N01 - Highways Response to SCC

Site: Land at Mount Avenue, Chaldon
Prepared by: RW/RA
Approved by: RAA
Date: 23/09/2025

SCC Request for Further Information

APPLICATION NO: TA/25/771

Existing Access Junction
Vertical Visibility

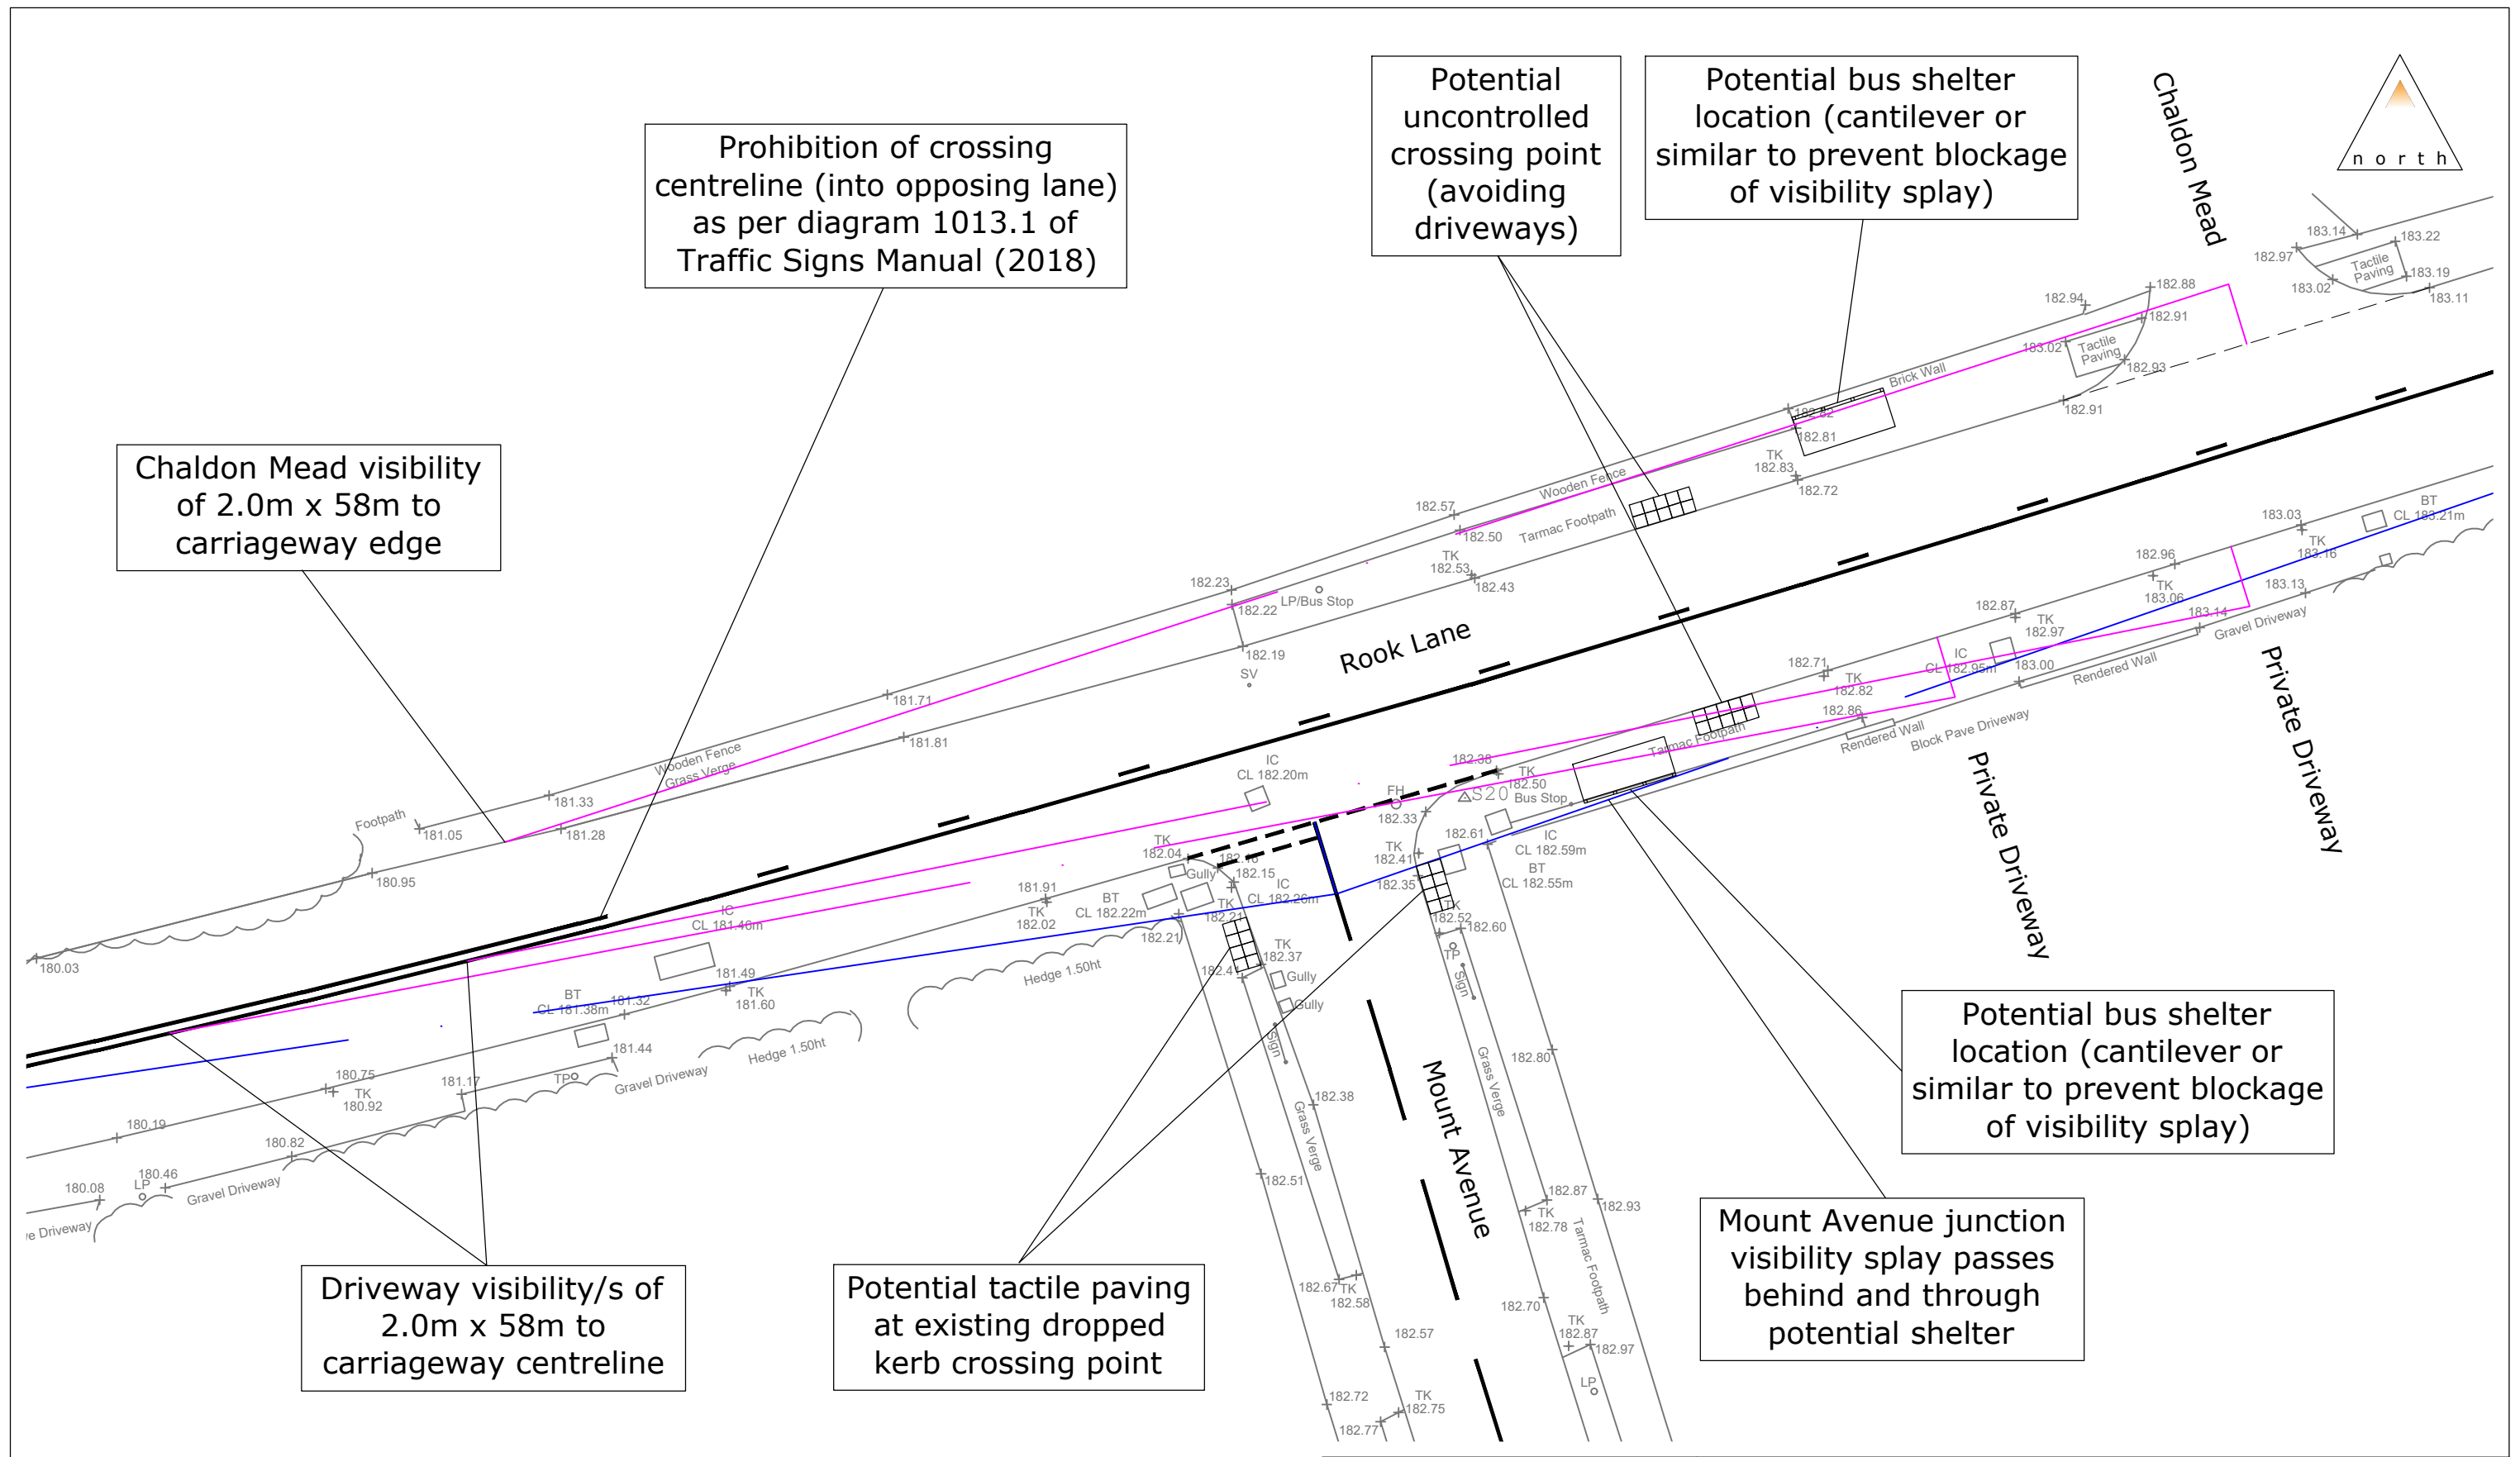
"1. Evidence of the vertical visibility splay to the west of the site access, in the context of the gradient on the B2031 (Rook Lane).

1. Evidence of the vertical visibility splay to the west of the site access, in the context of the gradient on the B2031 (Rook Lane).
2. Details of measures to provide a pedestrian crossing to access the bus stop on the northern side of the B2031 and of the potential to provide enhancements to the bus stops on either side of the B2031, close to the junction with Mount Avenue.

- 2.1 The vertical junction visibility at the existing junction of Mount Avenue with Rook Lane has been checked within Civil 3D CAD software using 3D topographical survey data. The achievable vertical visibility splay has been checked from a driver's eye height of 1.05m to a driver's eye height of 1.05m. The vertical visibility splay has also been checked from a driver's eye height of 1.05m to an object height of 0.6m. This has been plotted as a chainage to the west (trailing direction) of the existing junction as requested and for completeness, this has also been plotted to the east (leading direction) of the existing junction. The required vertical visibility is achieved in both directions, and this is illustrated in the drawing attached at [Appendix B](#).

- 4.1 SCC as county highway authority have requested confirmation of the vertical visibility splays from the existing junction of Mount Avenue with Rook Lane. Confirmation that the required vertical visibility splays are achieved has been provided.
- 4.2 SCC have requested investigation into the feasibility of a potential uncontrolled pedestrian crossing point (with dropped kerbs and tactile paving) providing enhanced crossing amenity between the existing bus stops. It has been demonstrated that this can be provided and that appropriate visibility for pedestrians would be available. The applicant would be happy to provide this crossing point through the associated S278 works.
